# 1984 Corvette: Service Bulletin: No Heat - A/C Control Unit

**Source:** Chevrolet Dealer Service Technical Bulletin

**Bulletin Number:** 83-T-70, Number Ia

**Date:** August, 1983

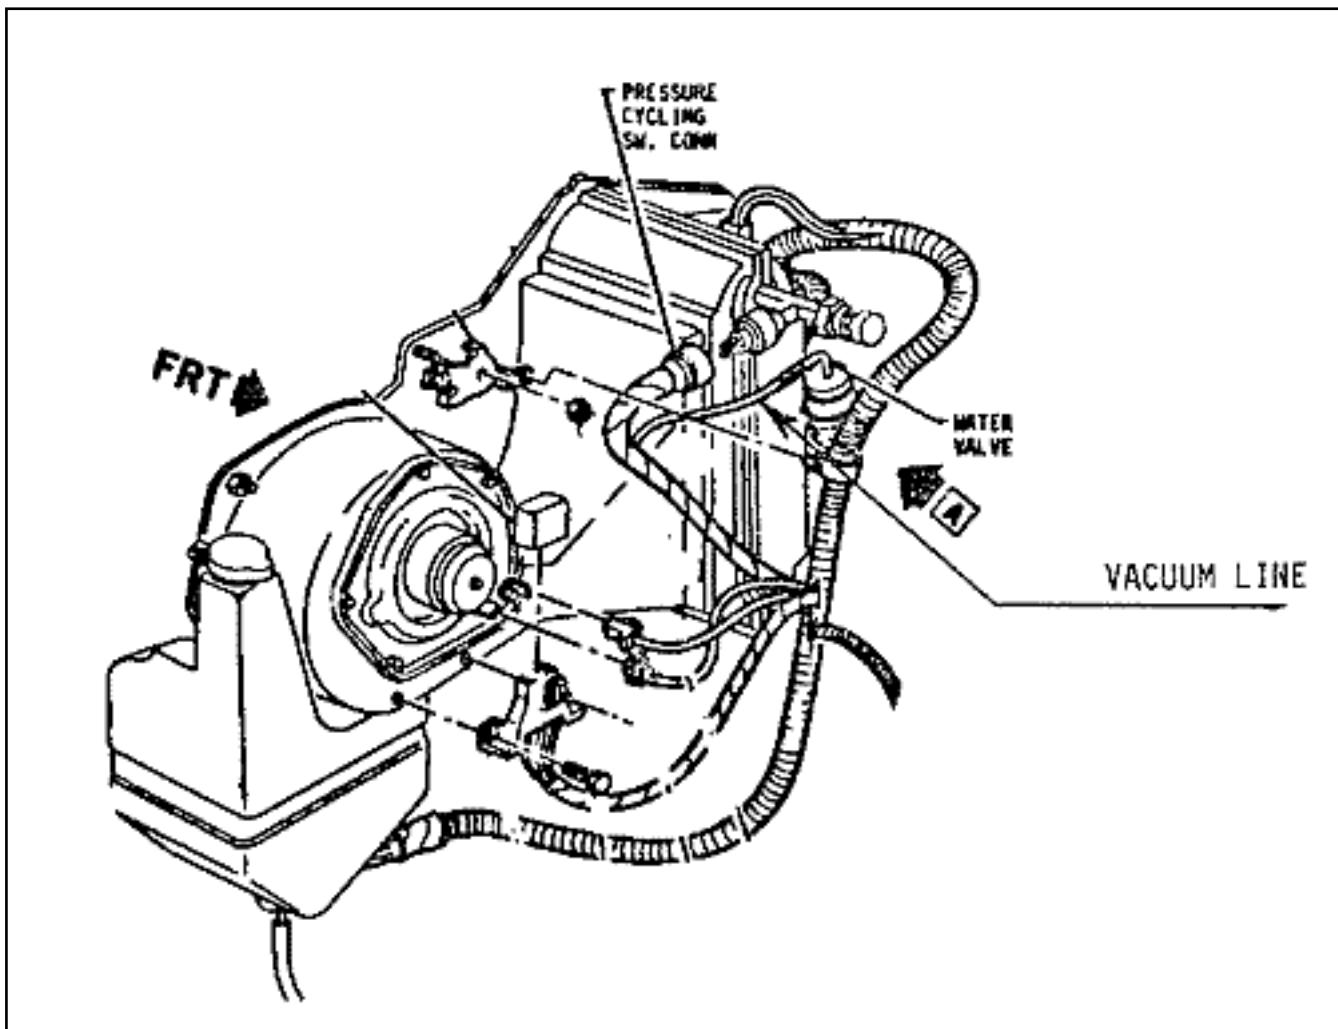
Conditions of "no heat" may be the result of a sticking vacuum switch within the A/C control unit. This may be more prevalent with lower temperatures. The switch may stick intermittently resulting in the condition going away and then resurfacing.

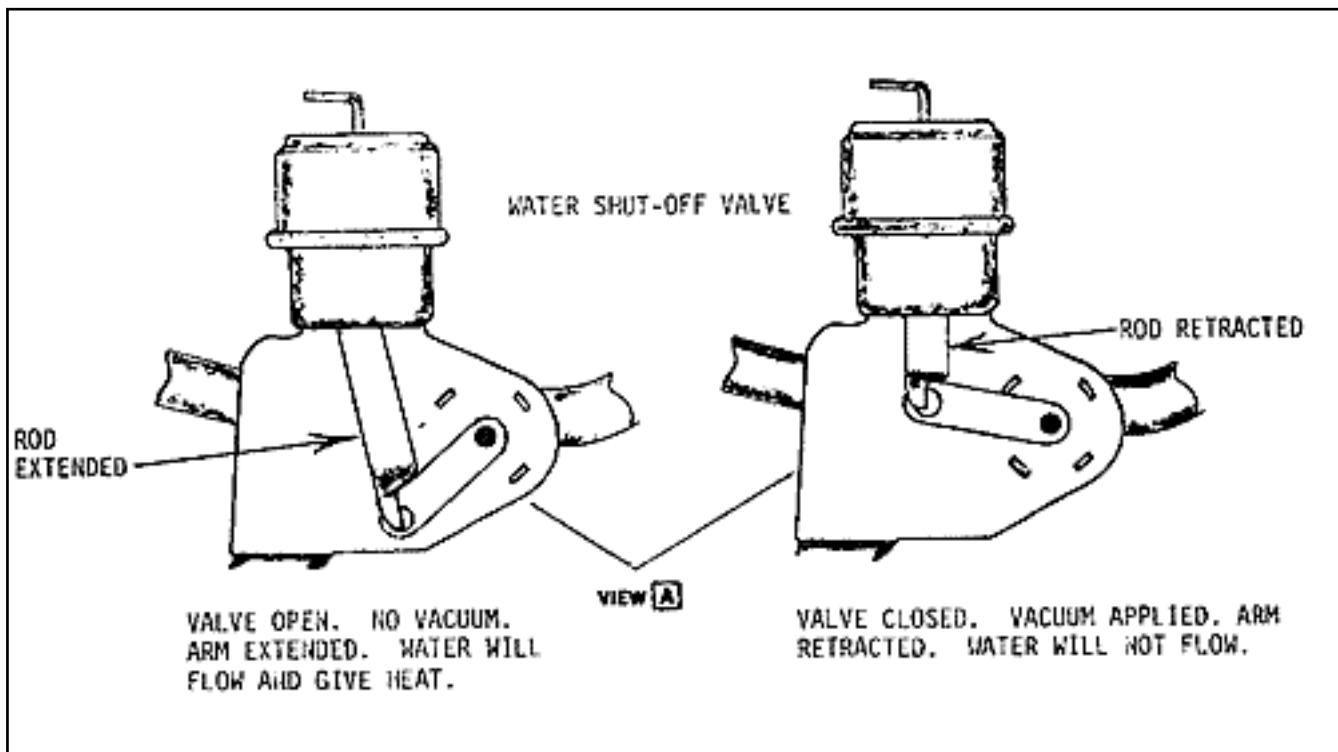
The vacuum switch in the A/C control unit controls a water shut off valve on the evaporator blower assembly. This valve should be closed with the temperature selector lever in the full cold position and open with the lever in any other position. Water will not flow through the heater core when the valve is closed (vacuum applied). Note that the valve actuating rod will be extended when the valve is open and retracted when closed (refer to sketch).

1. Observe the operation of the valve on the blower assembly while the temperature selector lever is moved from "cold" to "hot" position. The engine must be running to supply vacuum and should be at operating temperature.
2. If the valve opens (rod extended) when the temperature selector lever is moved to the "hot" position and heat output does not occur, the condition is not directly related to this particular control unit problem and should be further diagnosed, as described in Chevrolet Service Manual, Section 1.

3. If the valve does not open (rod retracted) remove the vacuum line from the valve. If this causes the valve to open and results in heat output, refer to Step 4.
4. Leave the vacuum line off the valve and seal off the end of the line to prevent a vacuum leak. (This can be done by fabricating a rubber plug or equivalent.) Secure the loose line to the harness with a band strap.
5. The vehicle can be operated with this line disconnected from the valve with no adverse effect to the A/C system.
